INTERDEPARTMENTAL COMMUNICATION

**Subject: Site Plan Special Permit 02/01/1989 – 307 – West Acton Village Ecology
525–541 Massachusetts Avenue & 3-7 Spruce Street**

Proposal for Added Crosswalk Safety Enhancements

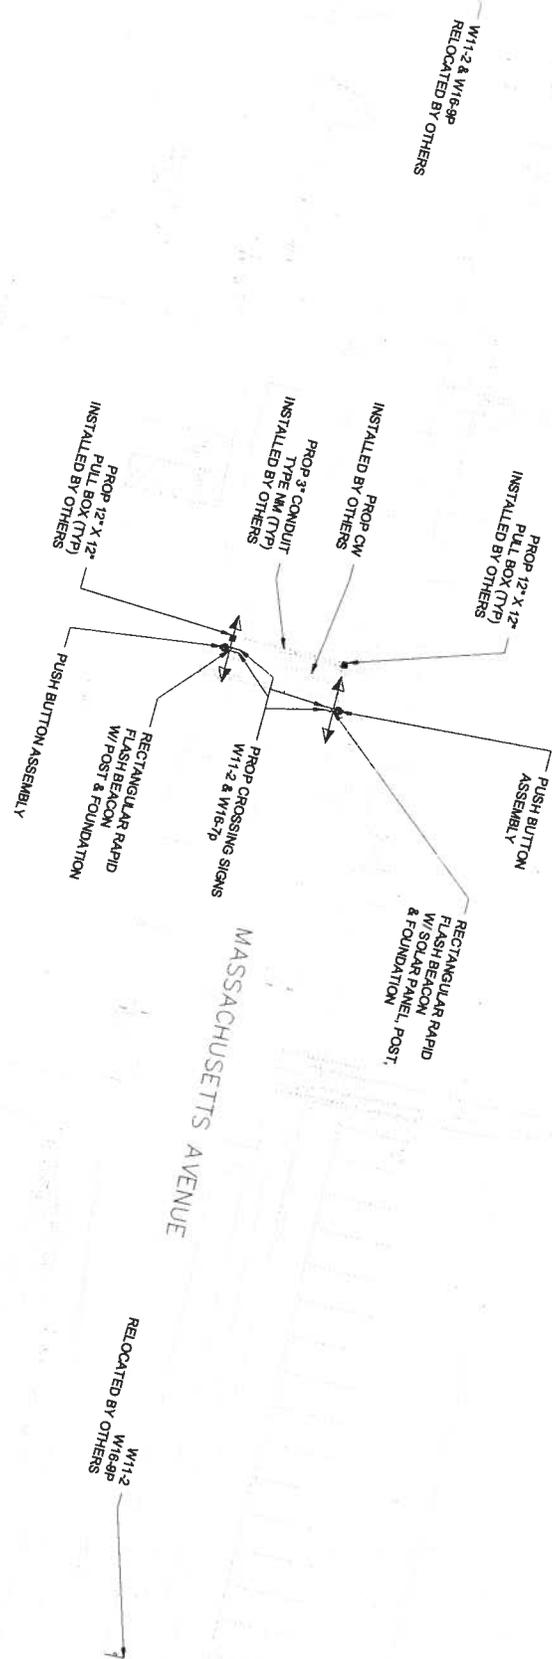
The applicant discussed this proposal with Municipal Properties, Engineering & the Highway Department. It is our understanding the applicant shall purchase and install this equipment. Once the equipment is installed and operational, the Town will assume ownership and future maintenance. Based on the manufacturer's information, the batteries will last around 3-5 years and cost about \$150-\$200 and the LED lights should last around 12 years and cost about \$500-\$600. The signs on either side of Mass Ave will be interconnected so the flashing beacons on both signs will flash when the button is pushed by a pedestrian waiting to cross the street.

- The signage, pavement markings and placement shall all comply with the latest edition of the Manual of Uniform Traffic Control Devices (MUTCD)
- Compliant accessible sidewalk ramps and landing areas on either side of the crosswalk. Adding detectable warning surfaces in conformance with design requirements such as for color contrast as set forth in the Proposed Accessibility Guidelines dated June 26, 2011. We have found that the surface mounted detectable units do not hold up to our routine winter maintenance operations.

We prefer the brick system and/or a recessed plastic unit similar to the crosswalk on Main Street at Town Hall.

- The need for an in-street crosswalk sign. The in-street signs are typically reserved for high pedestrian generators such as village center and school zones due to the higher costs and demands for ongoing maintenance, relocation and replacement.

Our other concerns relate to the need for additional safety enhancements due to the high traffic volume and speed. We have been evaluating our existing crosswalks on busier roads to be sure there is illumination. We are working on a plan to identify crossings that might need additional safety enhancements such as these pedestrian activated crossing signs.

This crosswalk seems like an appropriate location to install a RRFB crossing sign due to its proximity to the WAVE project, the other shops in the West Acton Center and the Gardner Field playground. We recommend the approval of this request by the WAVE project.
